R44

SERVICE BULLETIN SB-4

SUBJECT: Replacement of Guides for C121-7 Push-Pull Tubes

ROTORCRAFT AFFECTED: R44 Helicopters S/N 0001 thru 0150

FIGURE 1

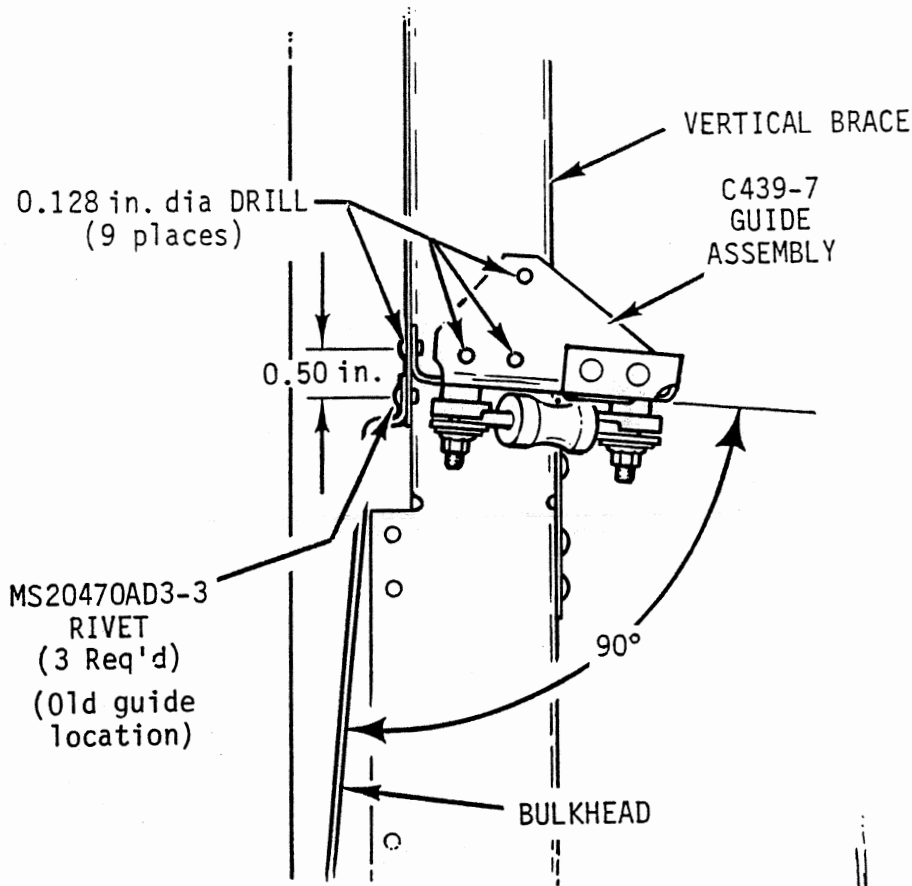
- 4) Remove rivets attaching push-pull tube guide to bulkhead and braces. Avoid kinking pitot line by sliding guide up to remove. To locate new guide, draw a line on bulkhead 0.50 inch above three rivet holes as shown in Figure 1. Position new guide with line on bulkhead centered on holes in guide flange and match drill three 0.128 inch diameter holes through bulkhead. Attach new guide using temporary fasteners.

- 5) Set guide at a 90 degree angle to bulkhead below guide (see figure 1). Using pilot holes in guide, match drill six 0.128 inch diameter holes through vertical braces. Remove guide assembly and de-burr holes. Rivet bulkhead three places at old guide location using supplied rivets. Insert pitot line through grommet in guide and rivet guide assembly to bulkhead and vertical braces using supplied rivets (9 places).
